Parcel C5

RM application

DC/22/94191

Condition 12 – Landscaping Plans

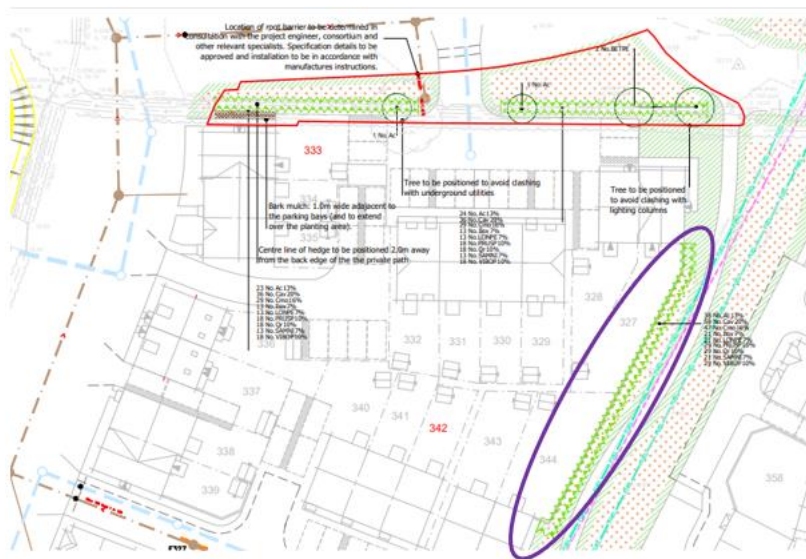
Please could you amend drawing PRJ01-TTE-00-XX-DR-L-603-1 rev B “Green Fingers – North of C5” to include a small additional element of Ligustrum vulgare in the hedgerow shown alongside the side boundary of plots 327 and 344 mix for biodiversity reasons and some green in the winter months as it is semi-evergreen..

Due to the fact that the drawings commented on - PRJ01-TTE-00-XX-DR-L-603-1 rev B - were prepared by the Landscape Consultants back in 2013 it is not possible to get these amended.

Vistry are willing to confirm that a small additional element of Ligustrum vulgare will be planted in the hedgerow shown alongside the side boundary of plots 327 and 344.
